Your ref: SSD-41294067
Our ref: DOC24/389597

Subject: Copi Mineral Sands Mine (SSD-41294067)

ATTACHMENT A – BCS Assessment Summary and Recommendations for Copi Mineral Sands Mine Environmental Impact Statement (SSD 41294067)

ATTACHMENT B – Detailed advice for Copi Mineral Sands Mine Environmental Impact Statement (SSD 41294067)

Figure 1: Example of the species polygon for *Austrostipa nullanulla*, not mapped to the extent of the associated PCT in accordance with the BAM.

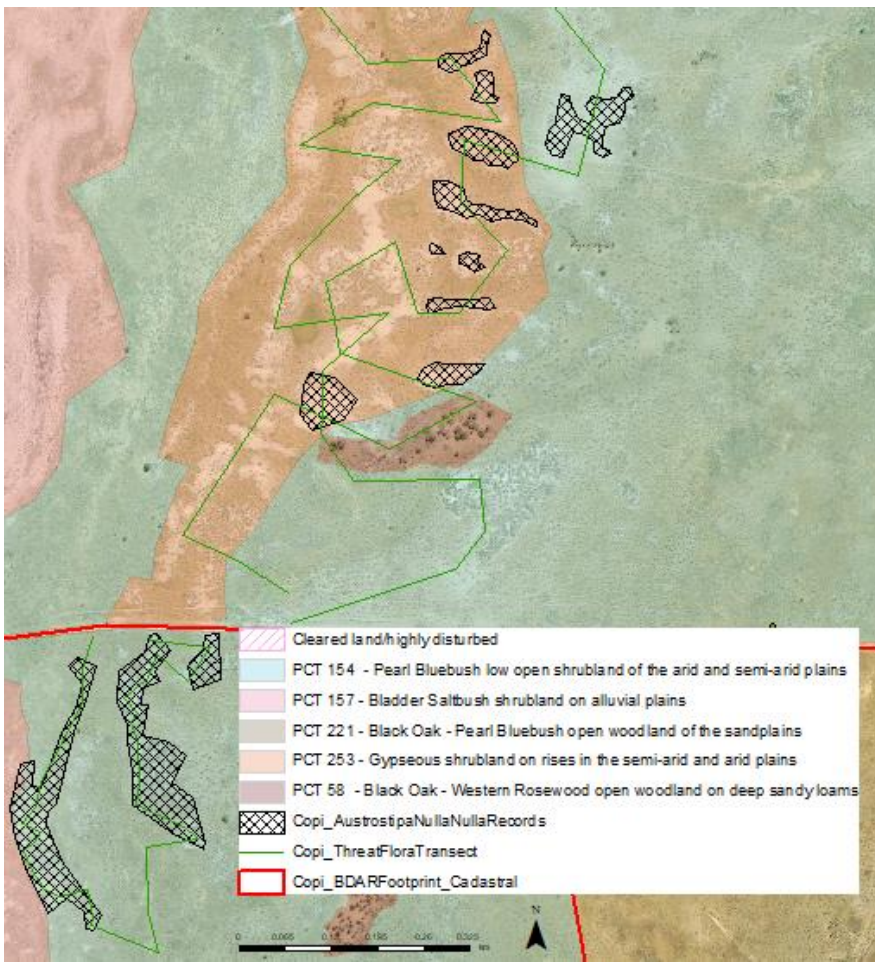
The BDAR provides no additional method or justification for why the species is not mapped to the extent of the vegetation zone even though there is a separate spatial data file called 'Copi_AustrostipaNullaNulla_PotHabitat' that maps potential habitat for the species and includes larger areas to the extent of PCT 253. There are other areas of PCT 253 that have not been surveyed (BDAR Figure 51 and 52) and are not included in the *Austrostipa nullanulla* species polygon.

Despite *Austrostipa nullanulla* only being previously known from associated PCT 253, in the mine site this species was also recorded in mapped areas of PCTs 154, 58 and 157. Parts of the species polygon spatial data fall outside the associated PCT 253 vegetation zone. It is unclear from the spatial data how the accredited assessor has developed the species polygon areas and their boundaries that are not in associated PCT 253 when the extent of the other PCTs in which it was mapped are very large (see example in Figure 1 below).

- 5.1. Revise the species polygon for *Austrostipa nullanulla* to match the extent of the associated PCT 253- Gypseous shrubland on rises in the semi-arid and arid plains, in accordance with s5.2.5 of the BAM.
- 5.2. Clarify how areas of the species polygon mapped outside the associated PCT 253 have been generated in the BDAR and revise species polygons in the BDAR and BAM-C where required.

Figure 2: VI plots for PCT 221 where 6 of 7 plots (selected in pale blue) are within 50 metres of access tracks, demonstrating plot placement not in accordance with s4.3.4(4) BAM.

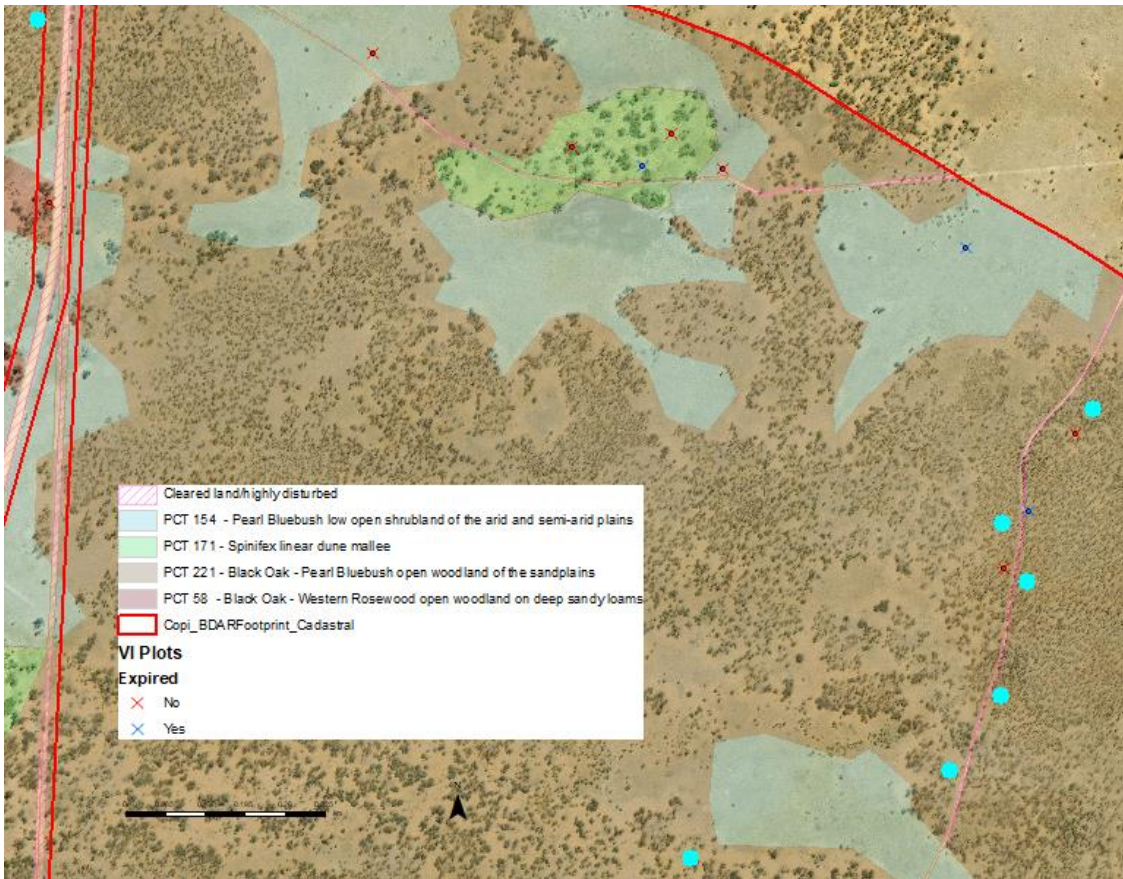
Although the assessor has completed a suitable number of VI plots for each vegetation zone (including one benchmark plot), the location of VI plots within vegetation zones is not likely to reflect the entire zone condition. For example, PCT 221 (moderate-good) is 457 hectares and requires seven plots. Six of the seven plots entered into the BAM-C for this vegetation zone are within about one kilometre of each other and six of the seven are less than 50 metres from a vehicle access track (**Error! Reference source not found.**). Similarly, the 2461 hectare vegetation zone PCT 15 (moderate-good) is spread east to west across the site but VI plots are clustered in three groups and all eight plots are less than 50 metres from access tracks (see Figure 2 and Figure 3).

In accordance with s4.3.4(4) of the BAM *'Plot boundaries should not be established within 50 m of ecotones, vehicle tracks and their edges, or other disturbed areas that are easily distinguishable from the broad condition state of the vegetation zone'*. Most of the vegetation zones in the BDAR do not comply with s4.3.4(4) of the BAM. In addition, there are multiple large sections of the subject land that have no VI plots, and no other flora or fauna surveys points.

- 9.1. Sample additional VI plots across the vegetation zones to demonstrate that vegetation condition across the subject land has been adequately sampled and considered.
- 9.2. Where vegetation condition is variable across a zone, create additional vegetation zones with different condition states and complete the required VI plots in accordance with s4.3.4 of the BAM.
- 9.3. Resample VI plots where current plot placement does not meet s4.3.4(4) of the BAM.

Figure 4: Example of a location where indirect and prescribed impacts have not been considered for salt lakes that will be impacted by the development footprint.

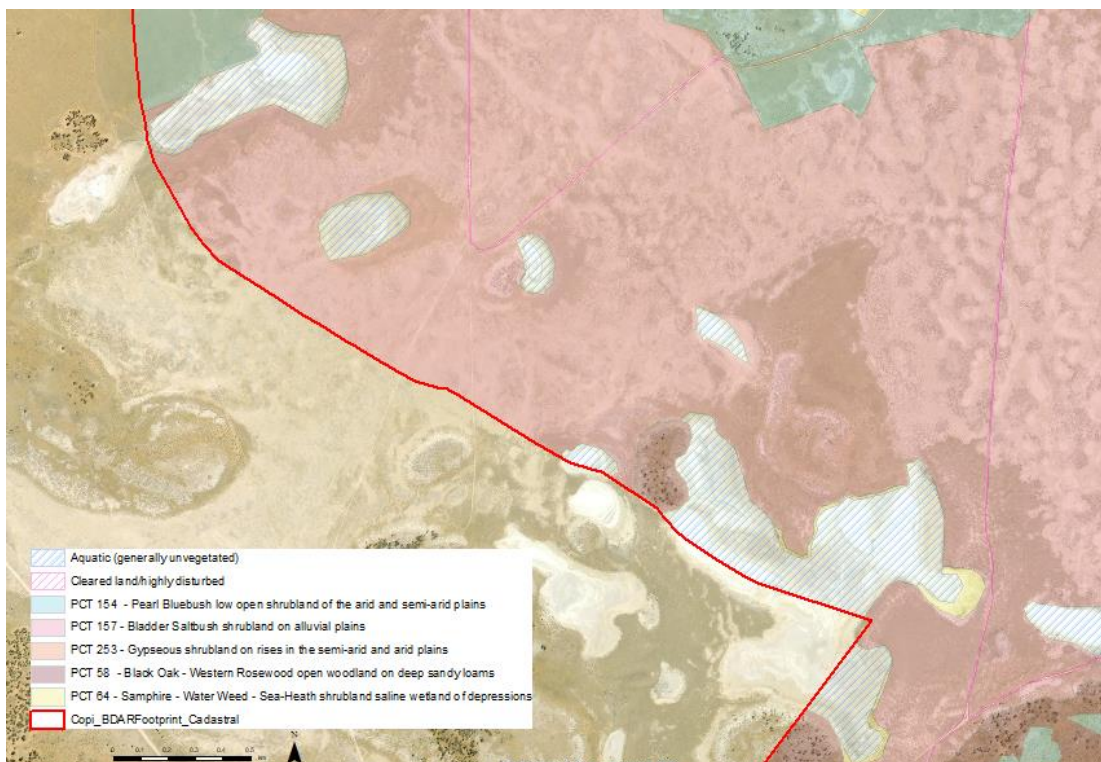
BCS notes that even though Section 8.3.3 of the BDAR provides general comments on the possible impacts to the salt lakes, the BDAR does not address the specific indirect and prescribed impacts of the project on local hydrology. For example the BDAR does not identify key features relevant to assessing how the proposal may affect how the local systems functions. BCS are concerned that removing sections of individual salt lakes will result in complete loss of function for that lake, and potentially for the broader system of lakes (see Figure 4).

- 15.1. Revise the hydrology prescribed impacts for threatened species to include all threatened species likely to be affected by the proposed development.
- 15.2. Propose avoidance and mitigation measures that contribute to the entities impacted by prescribed impacts recovering.
- 15.3. Identify residual indirect and prescribed impacts to hydrology and connectivity of threatened species.
- 15.4. Propose measures for offsetting residual prescribed impacts if residual prescribed impacts are identified.
